**REGULAR MEETING OF THE
CITY OF ALVARADO PLANNING AND ZONING COMMISSION
104 W. COLLEGE AVE.
MAY 16, 2024
6:30 PM
AGENDA**

This letter is to inform you that the attached Lone Oak Addition Phase 1 final plat application provided on April 22, 2024 has generated the recommendation of disapproval from the Alvarado Planning and Zoning Commission due to the following comments not being adequately addressed to result in compliance with the Alvarado subdivision ordinance.

ENGINEERING PLANS
FOR
LONE OAK PHASE 1
CITY OF ALVARADO
JOHNSON COUNTY, TEXAS
MARCH 2024

City Engineer Remarks on Preliminary Plat and Preliminary Engineering

STM A3-B

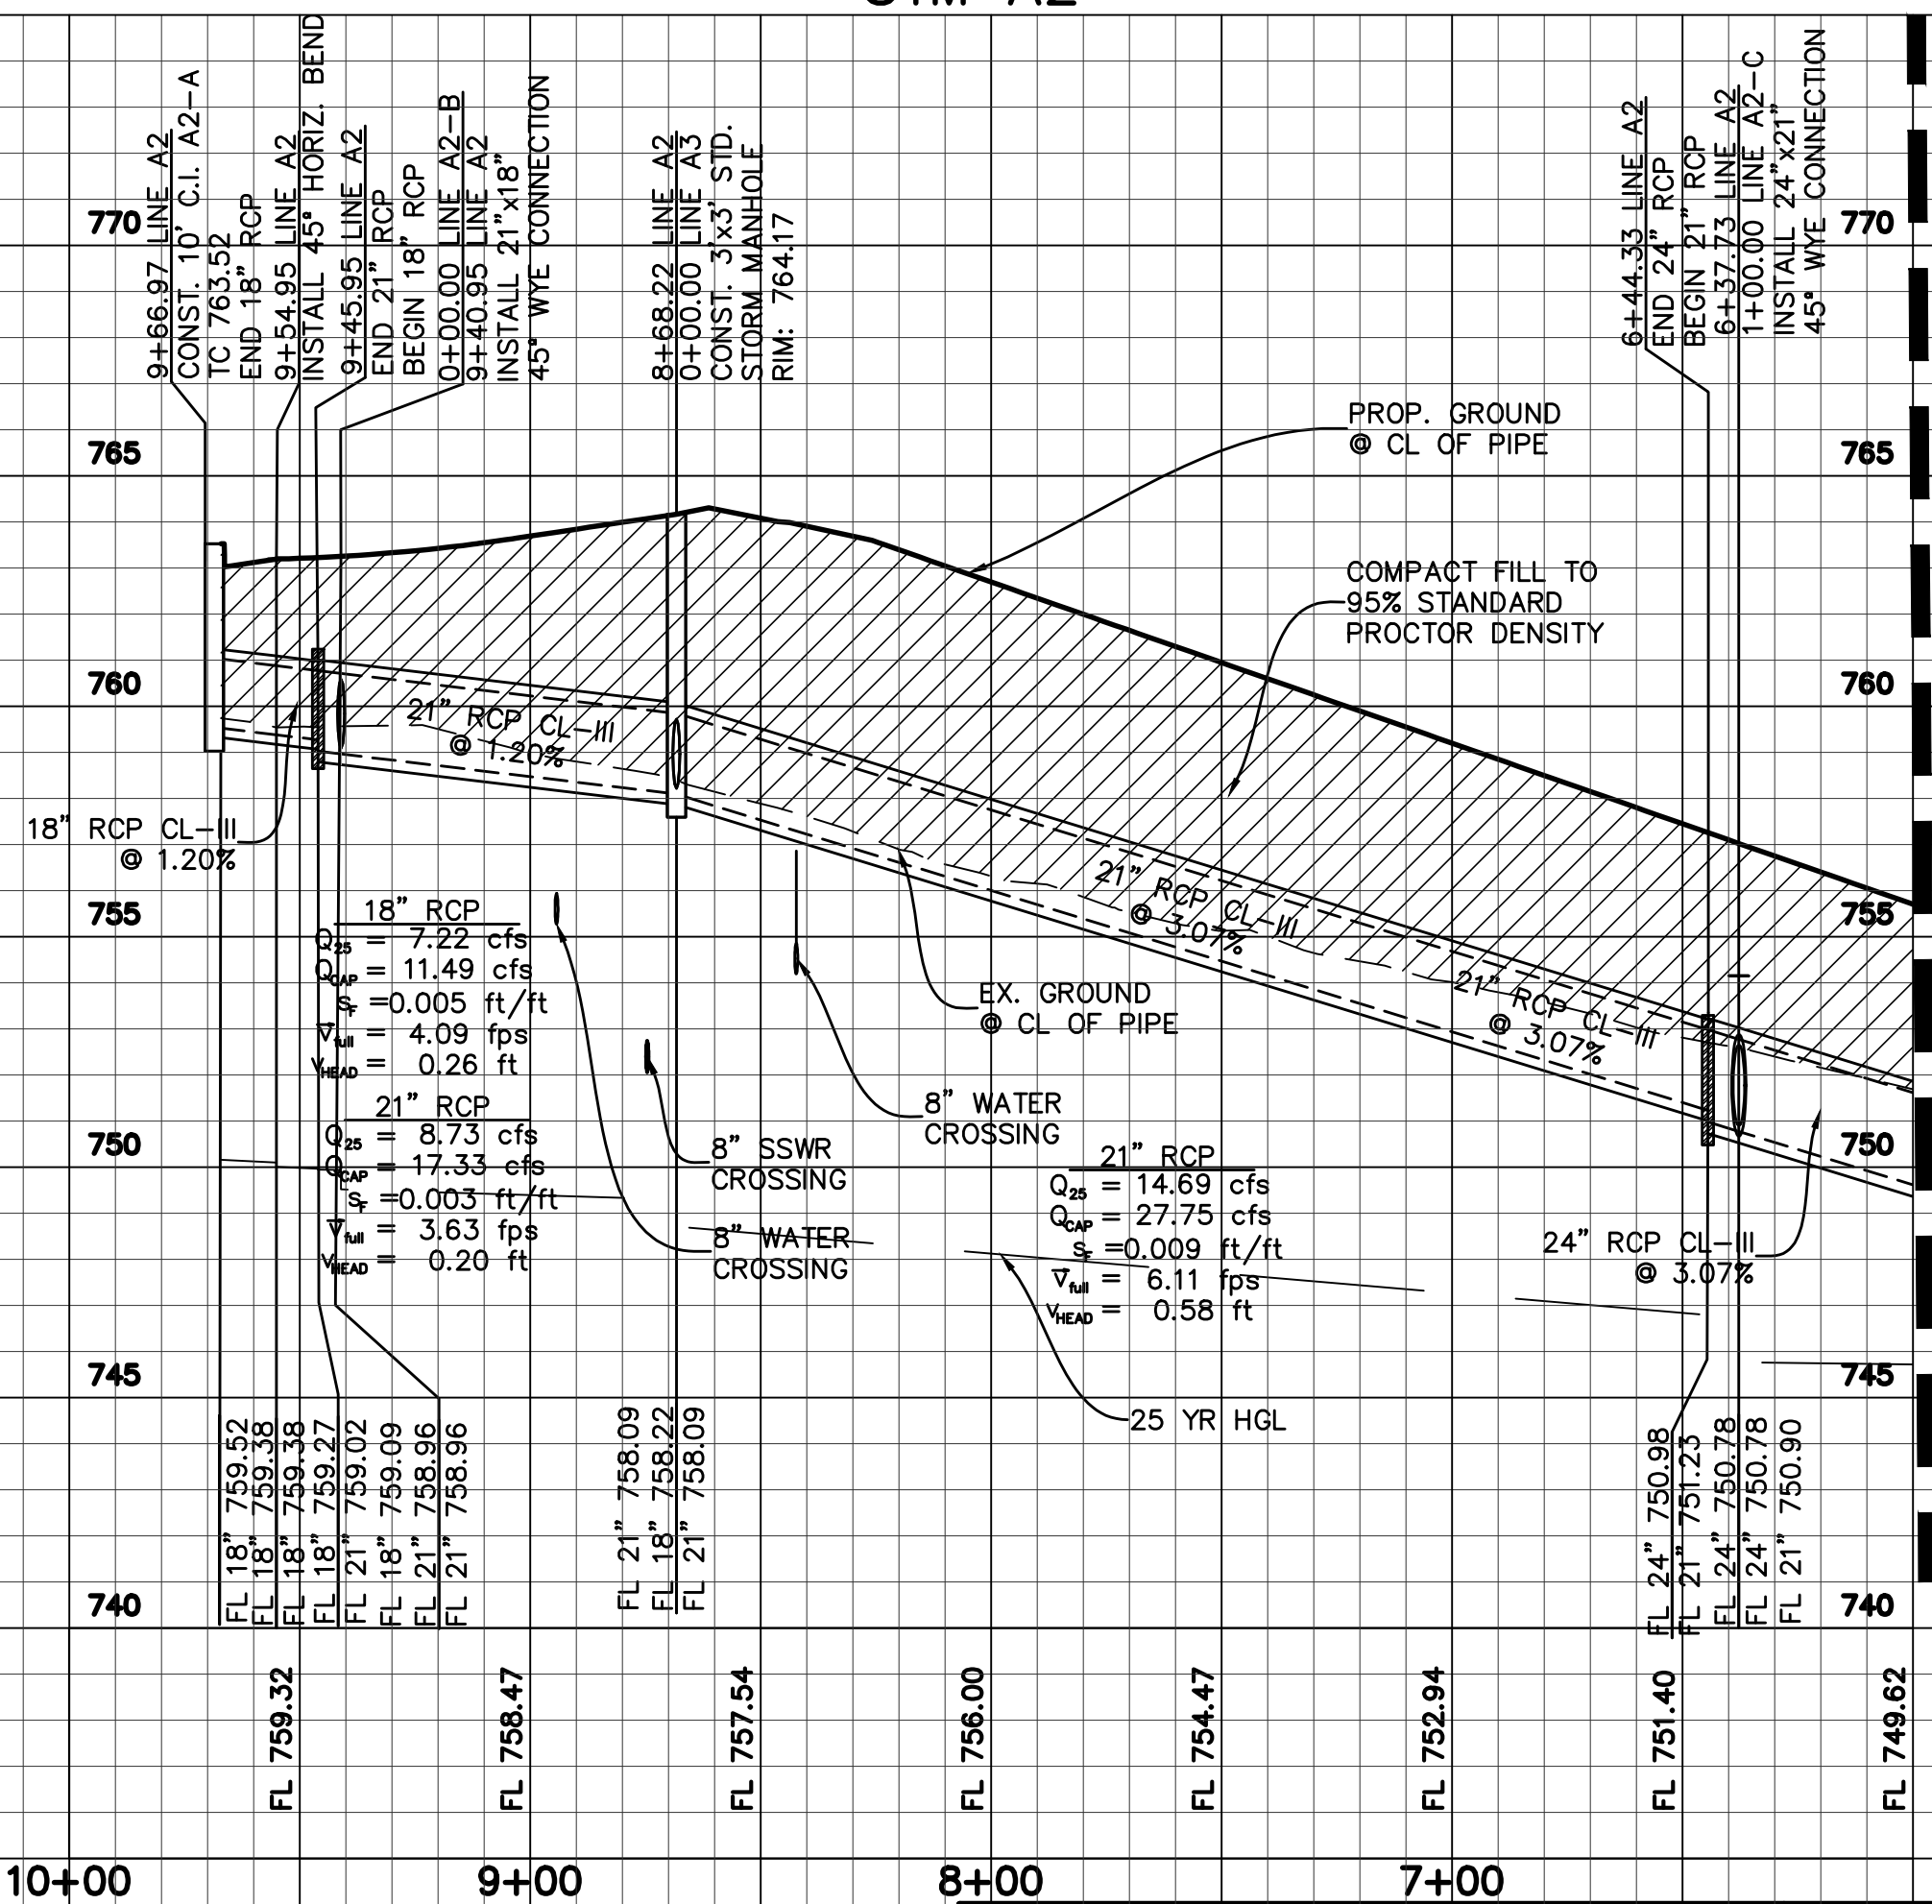
Recommend aerators in the retention pond

PROJECT NO.	BBC010
SHEET NO.	5.06

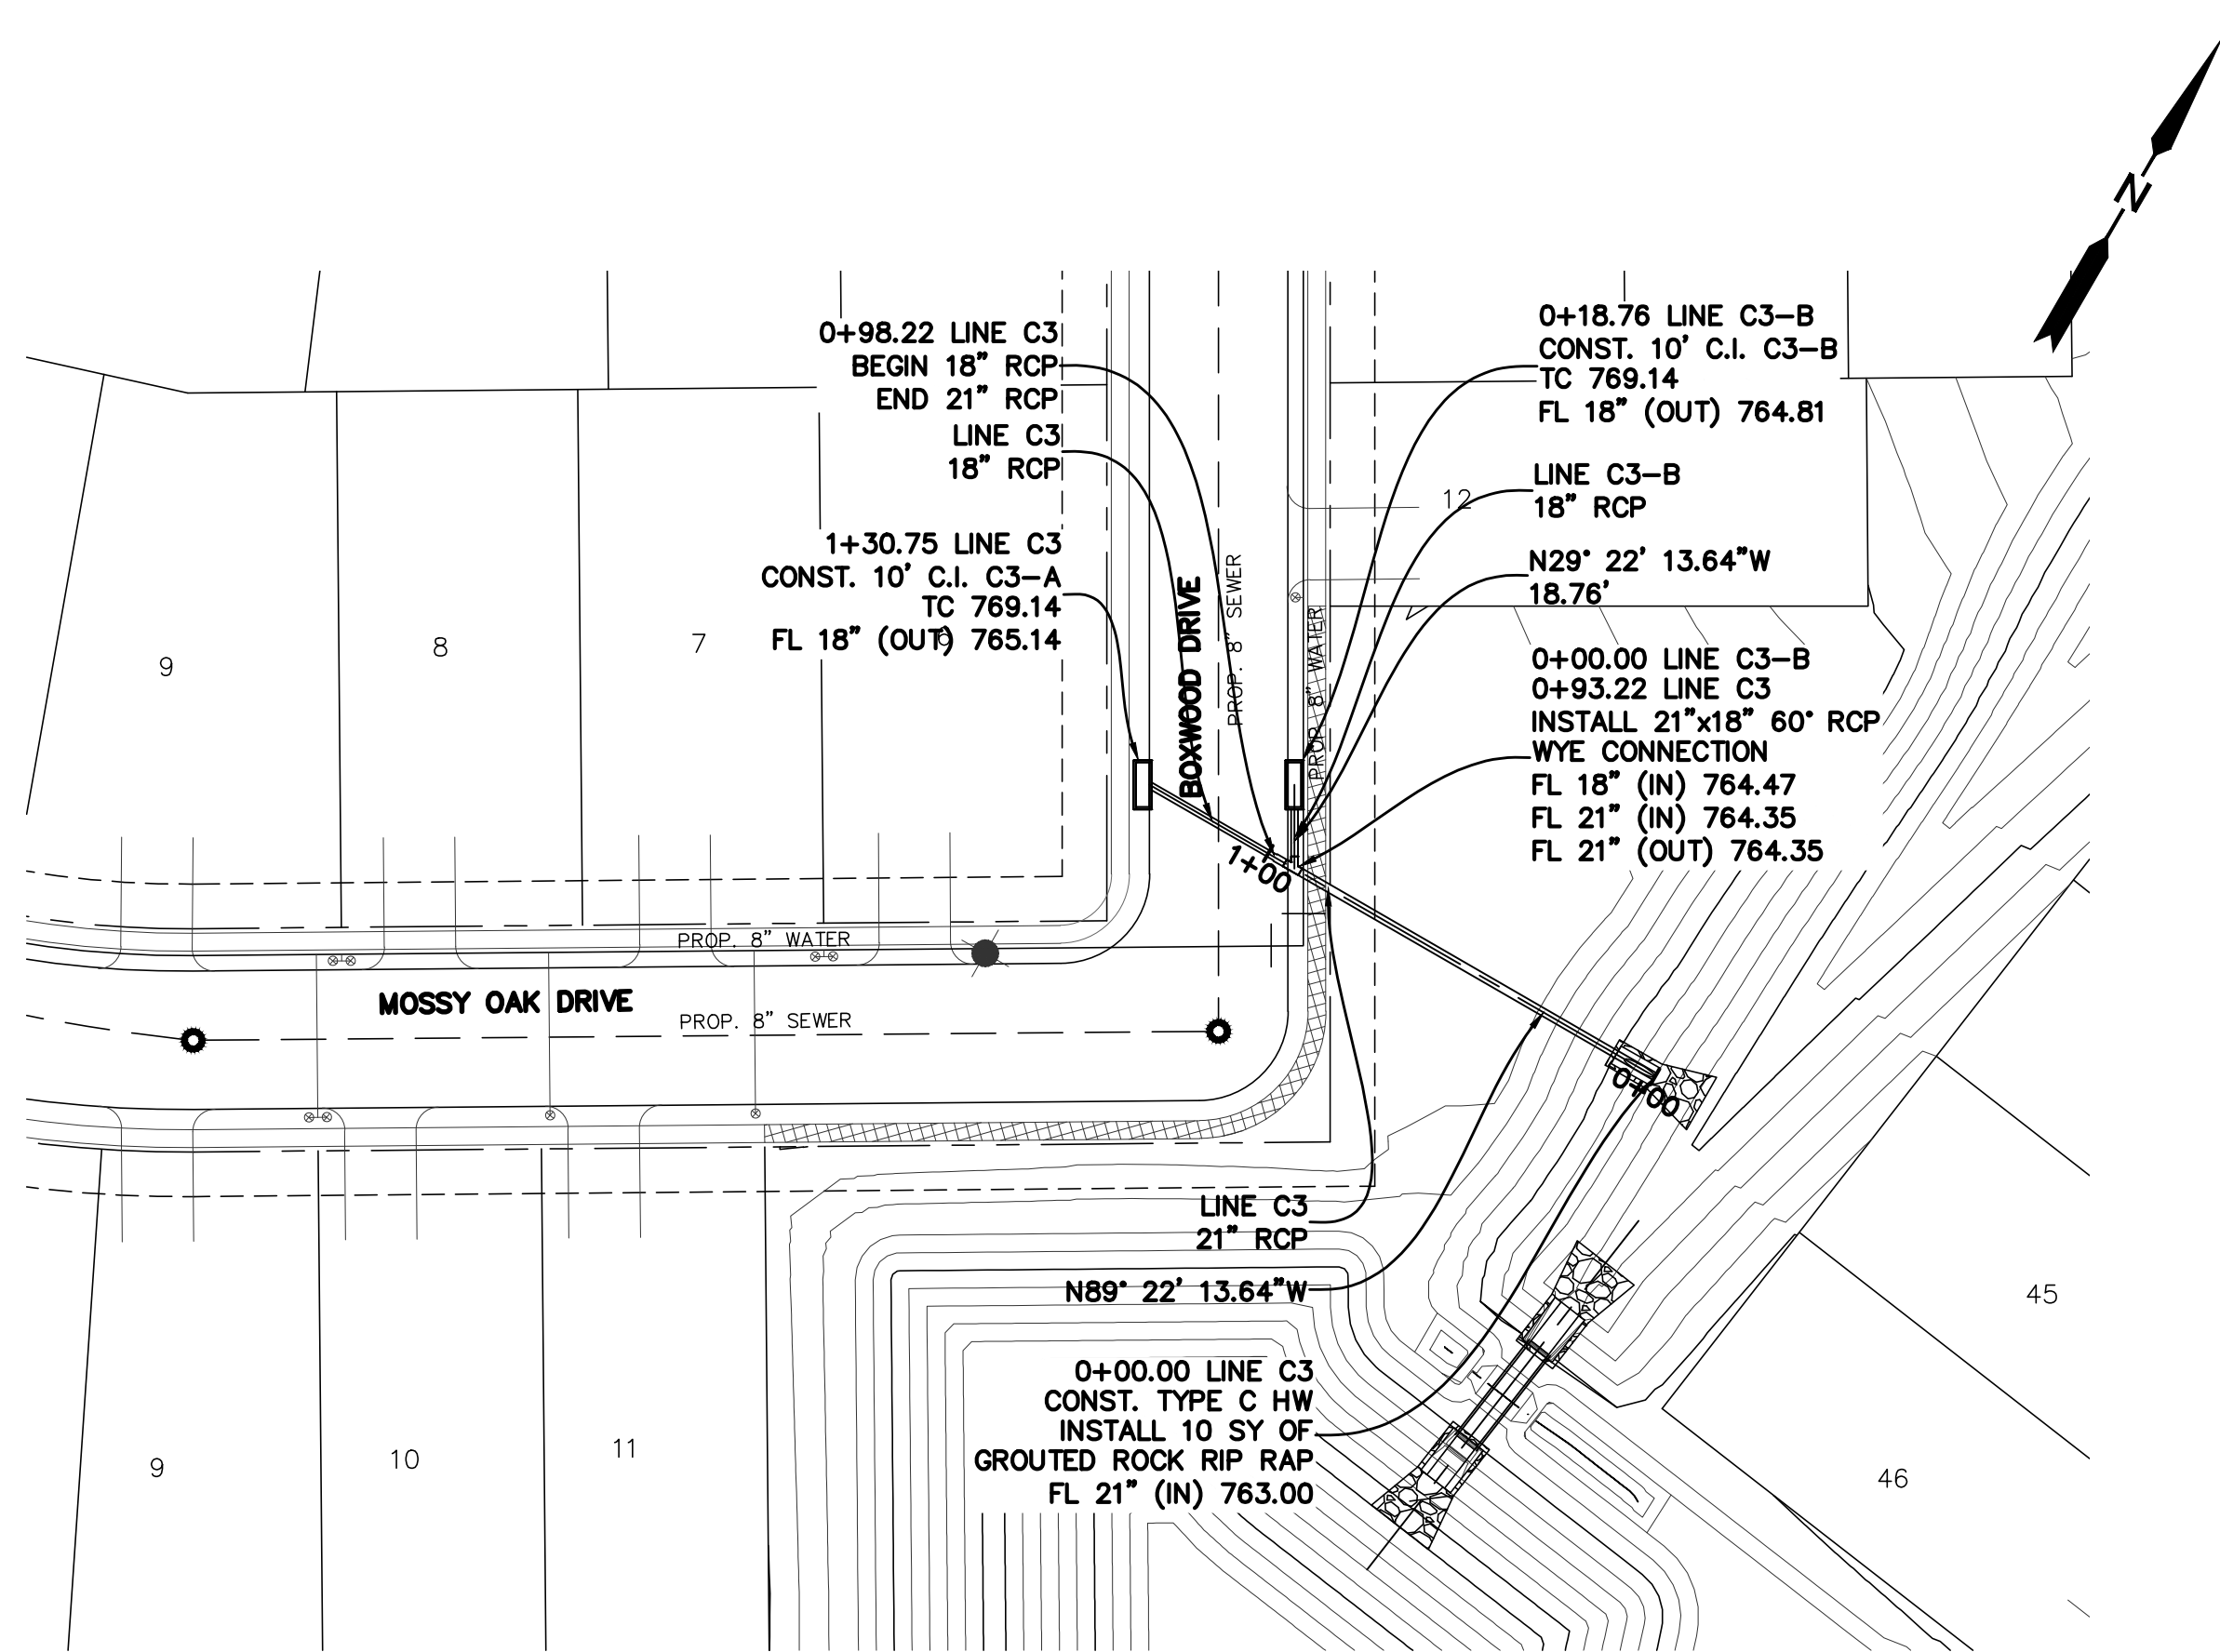
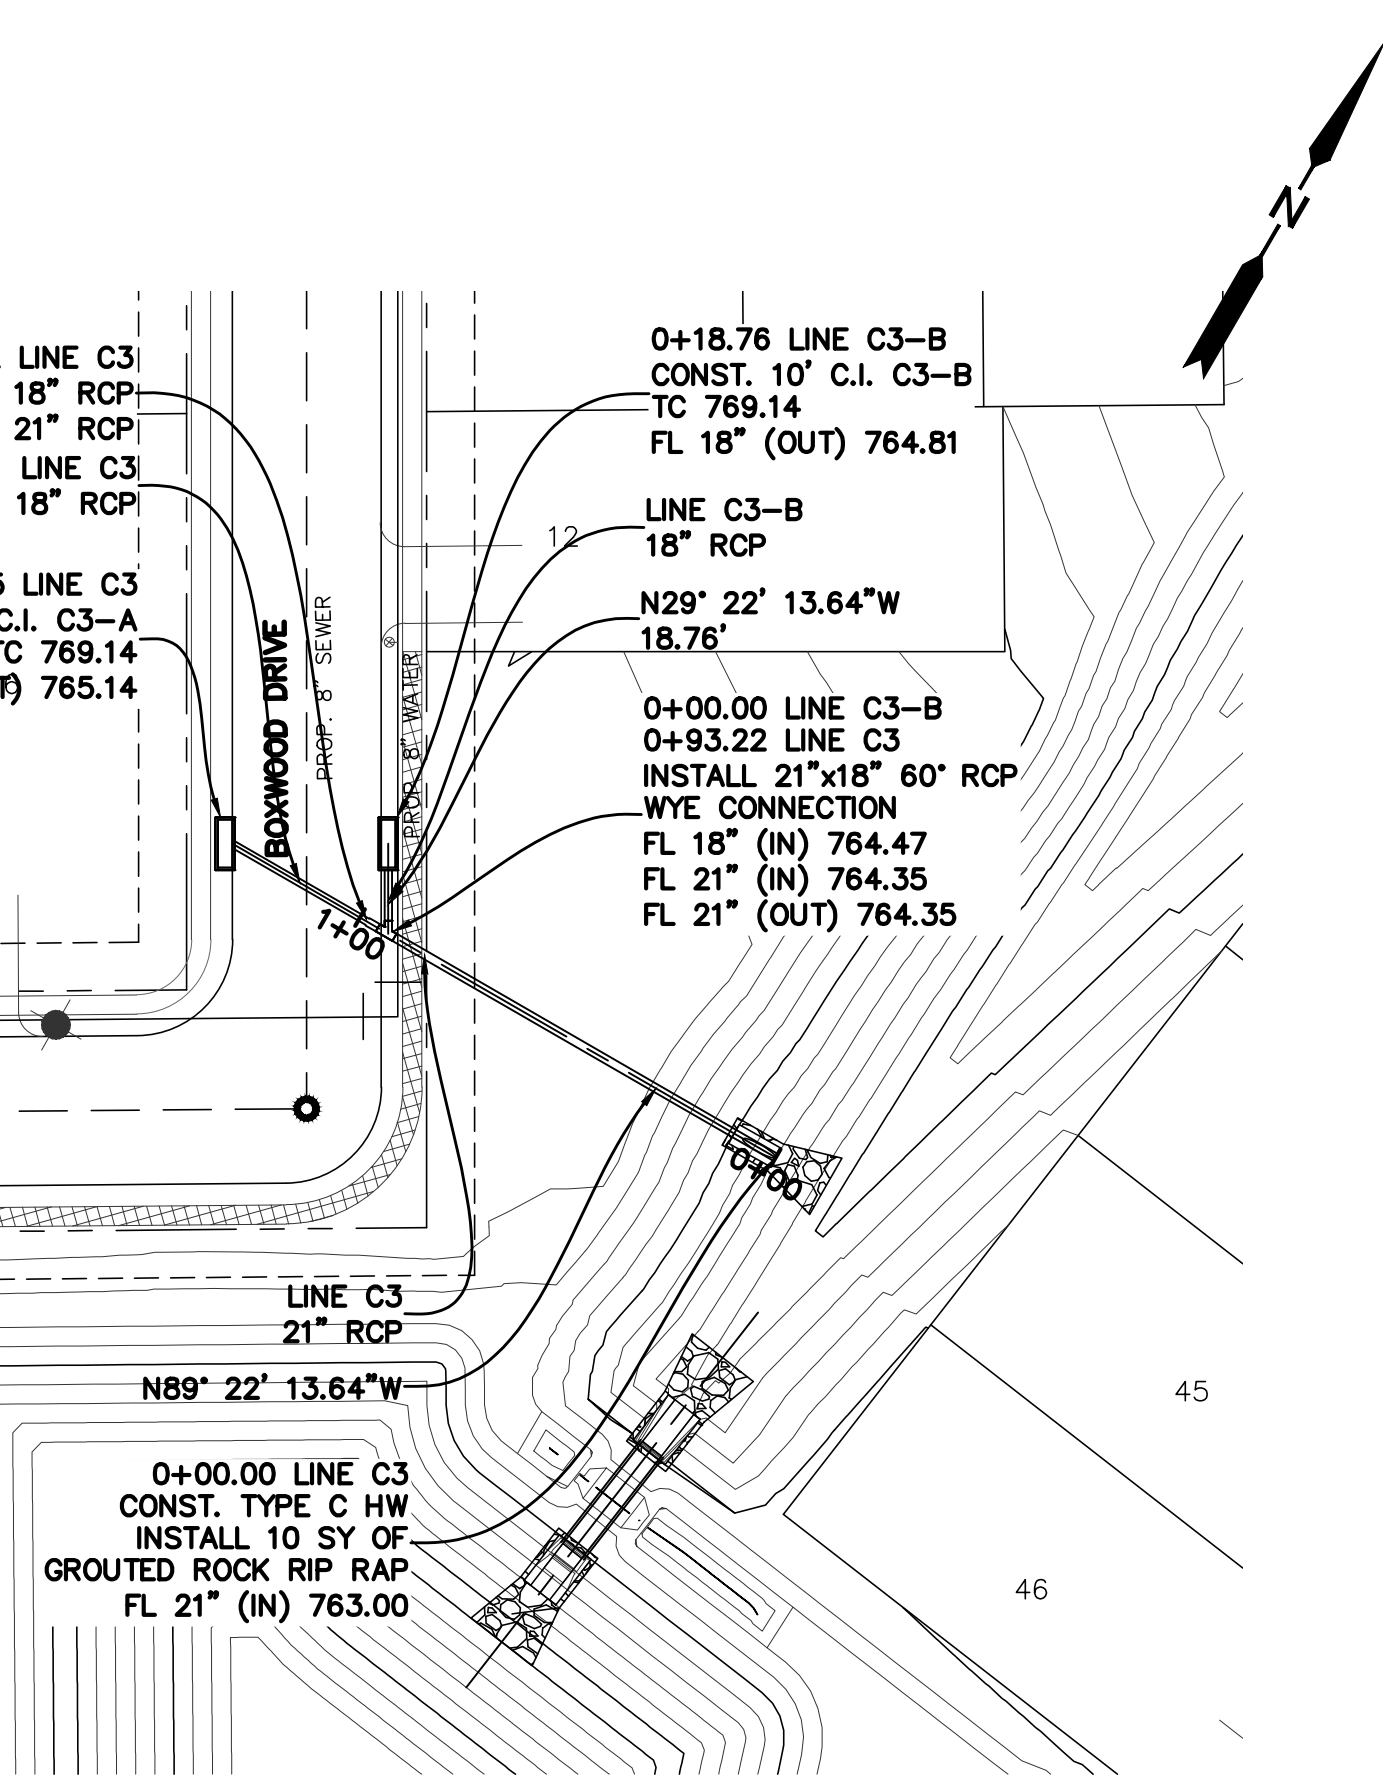
Where are the storm calculations for the box culverts?
